MENARD, INC.**Addendum #2
Kokomo, IN
Phase I - Detached Warehouse/Guard Shack**

March 5, 2007

THE FOLLOWING ADDITIONAL CLARIFICATIONS AND/OR CORRECTIONS ARE MADE TO THE PLANS AND SPECIFICATIONS.**Bid Date Extension:**

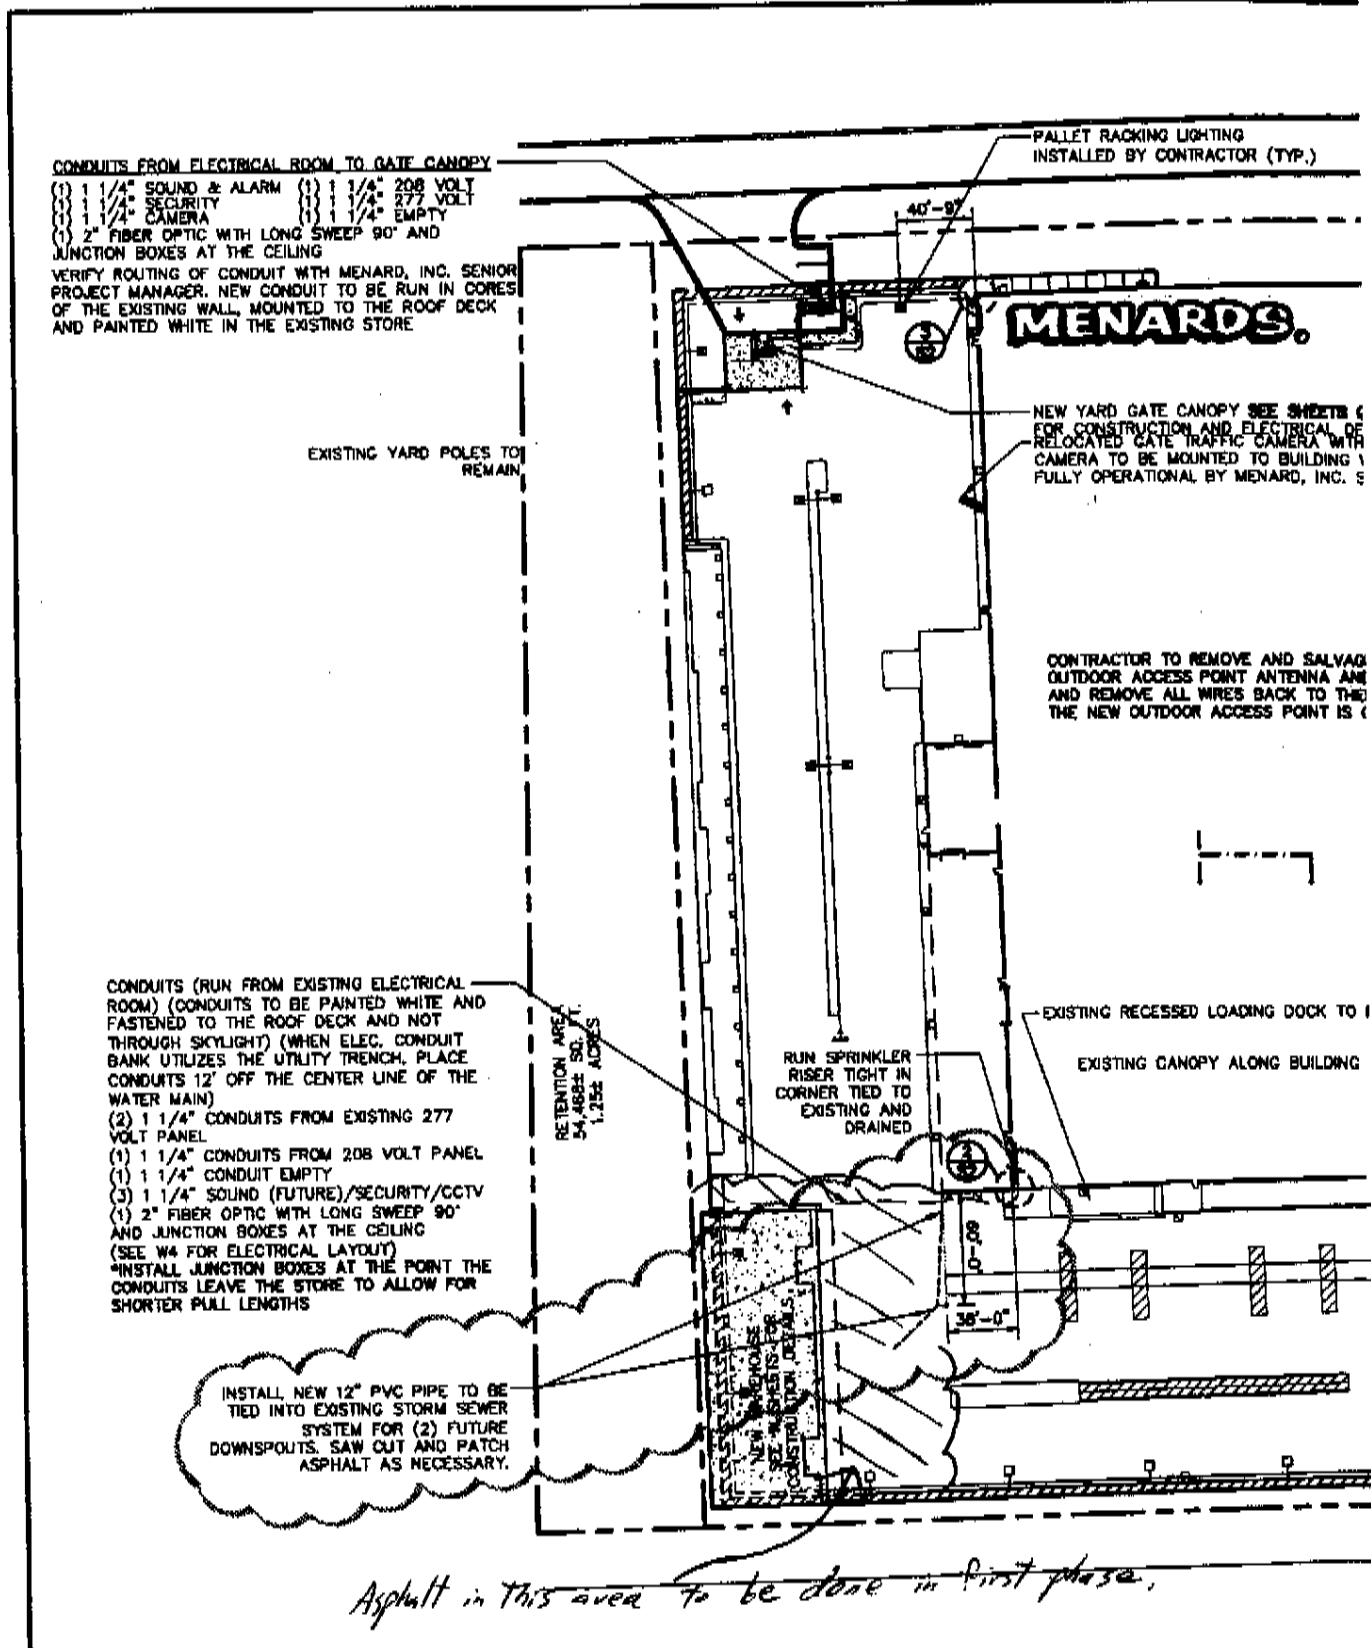
1. **Storm & pavement work:**
Pavement replacement is now to be from SW corner of existing building, south to pallet rack fence and West to the NW corner of the new warehouse approximately 20' North of the warehouse. Asphalt must be placed in phases to allow customer traffic access to yard at all times. Storm inlet #4 is to be completed in this phase as well as the storm lines for the garden center downspouts. The garden center storm lines are to be installed now and stubbed up for future connection. Inlets 1,2 and 3 and asphalt around them to be done during a later phase. See site plan.

Asphalt in this area to be done in first phase.
